NO: SW - 114	PRODUCT: A6E-N – Dip Switches
DATE: January 2017	TYPE: MODIFICATION – Structure and Shape Change

A6E-N DIP Switches: Upgraded to Semi-Sealed Construction

A6E-N Details of the Changes:

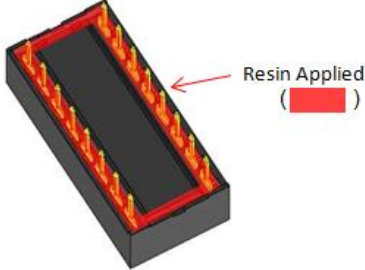
In an effort to enhance product reliability of Omron’s line of Dip Switches, OMRON will modify the structure and cover of the listed A6E-N models effective as our production beginning July 2017. The newly modified A6E-N Dip Switches will now be semi-sealed to prevent contact failures caused by flux ingress. PCB layout and overall dimensions will remain unchanged. Please carefully read through this notification and note the differences; the models to be affected include, but are not limited to the models listed below; should you have any additional questions, however, please communicate with the Switch Product Specialist.

Before the change	After the change
<p>Current resin application location - None (Resin is not applied between Base and Cover.)</p>  <p>Cover Shape</p> 	<p>New resin application location *Resin is applied between Base and Cover.</p>  <p>Cover Shape</p>  <p>*NOTE: Resin color is shown red for illustration purposes only. There is no change of the product performance / dimension.</p>
